ADDENDUM NO. 2

RE: **Kitchen Improvements at Gauger-Cobbs Middle School**
50 Gender Road, Newark, Delaware 19713

for
Christina School District
700 North Lombard Street, Wilmington, Delaware 19801
EIA Project No. PP7279

FROM: EI Associates, Architects and Engineers
2001 North Front Street, Building 3
Harrisburg, PA 17102-2118

TITLE: PARTIAL FIRST FLOOR PLAN
 PROJECT: GAUGER-COBBS MIDDLE SCHOOL
 50 GENDER ROAD NEWARK, DE 19713
 CHRISTINA SCHOOL DISTRICT

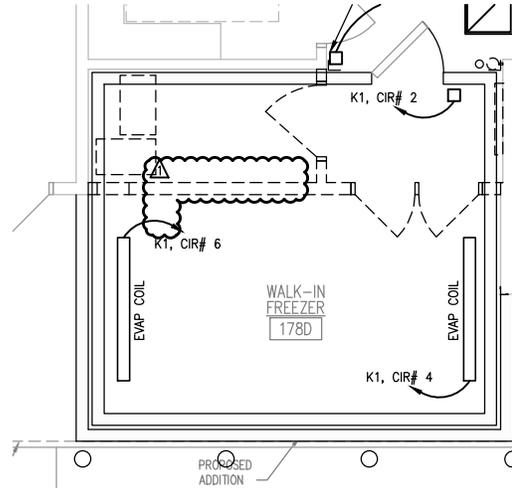
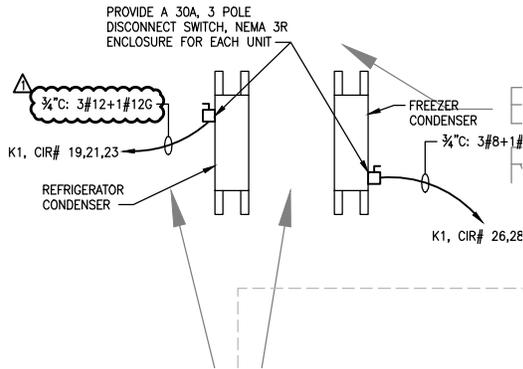
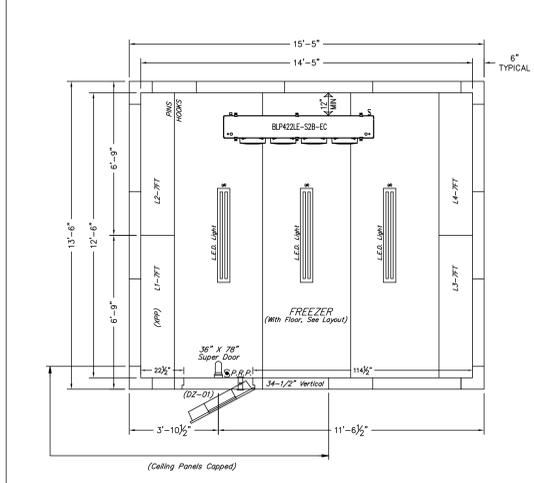
- 2.16 Drawing E1: Revise Partial Floor & Roof Plans and New Power Panel Schedule as shown by clouded marks on supplemental Drawing ESK-1, copy of which accompanies this addendum.
